ADDENDUM NO. 1

PROJECT NAME: PITTMAN-SULLIVAN PARK IMPROVEMENT

DATE: September 3, 2013

CIMS PROJECT NO.: 40-00387

3 CONCRETE POLE BASE DETAIL
 NOT TO SCALE

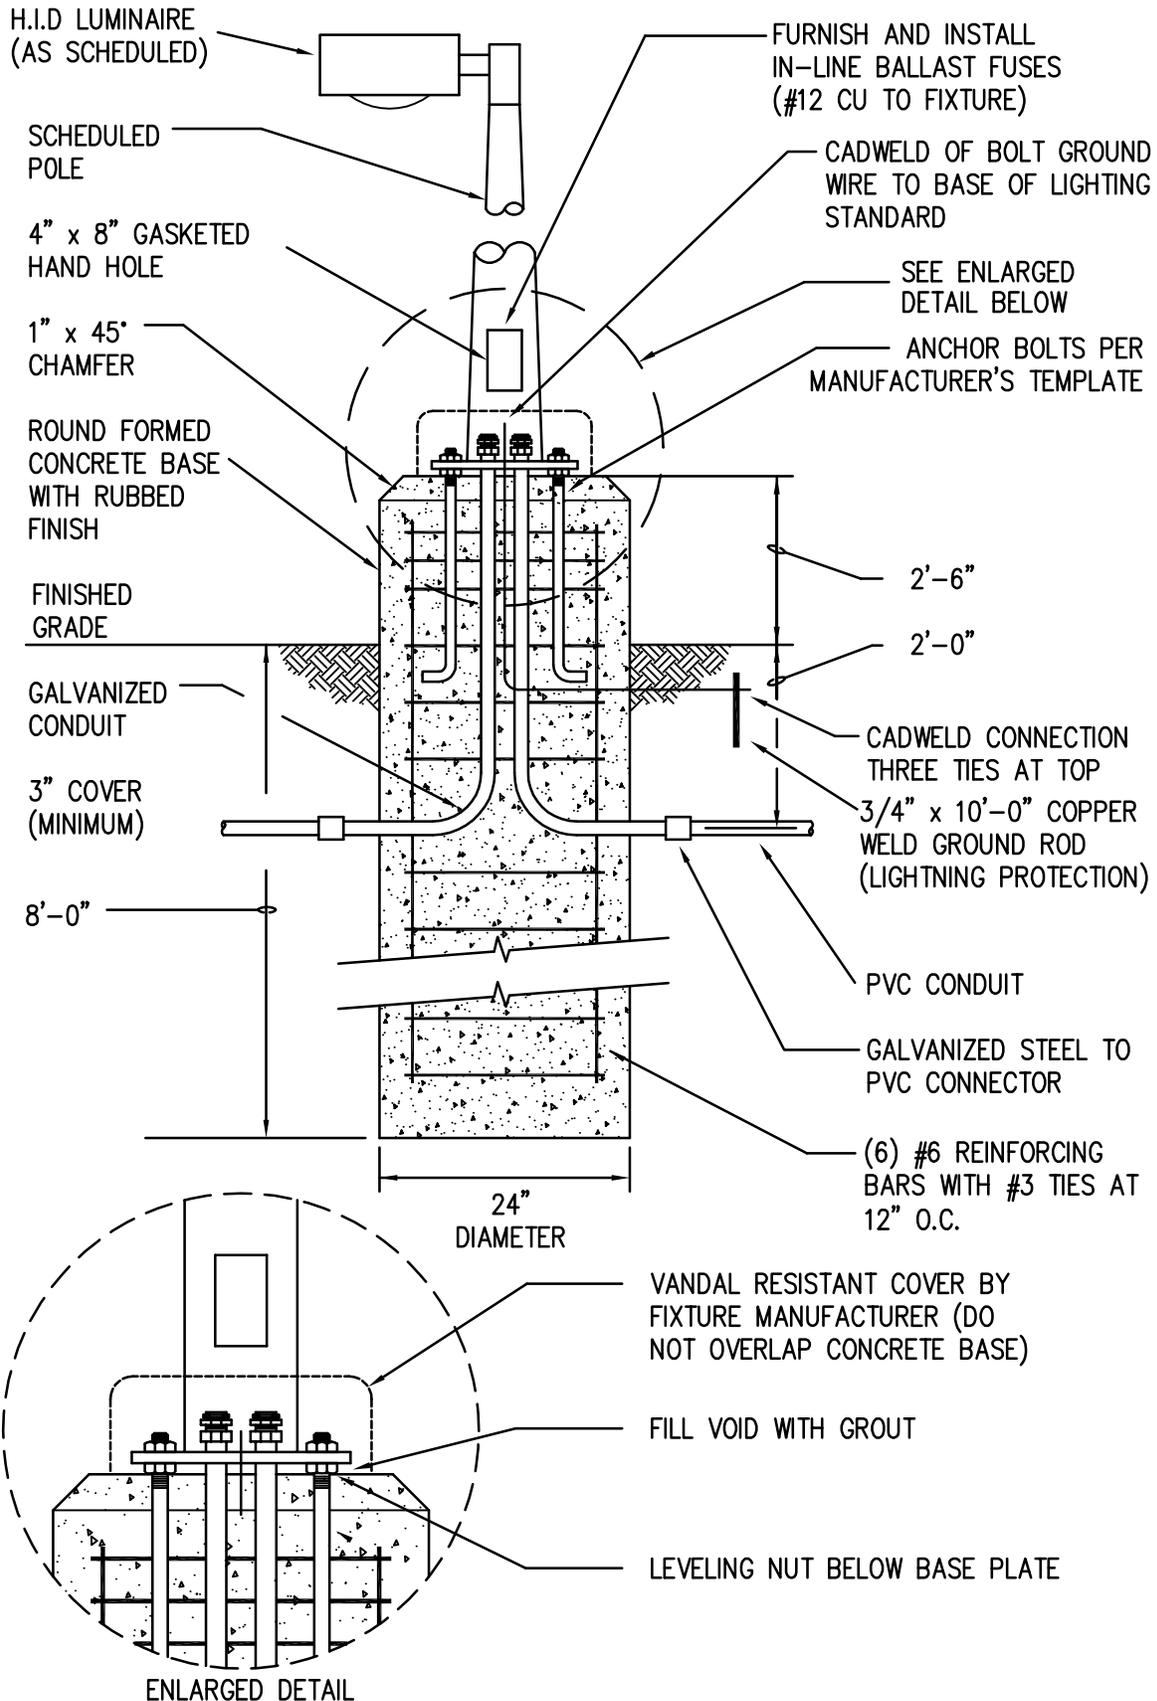
1. The 025 - Unit Price List has been revised to remove the duplicates found on #22, 23. & 24.
The revised form is attached in PDF form.
2. Please find attached Detail 3 – Concrete Pole Base Detail as indicated on Sheet E3

NOTE: PROVIDE POLE BASE PER MANUFACTURER RECOMAINADATIONS FOR THIS AREA.
 THE CONCRETE POUR SHALL BE MONOLITHIC.
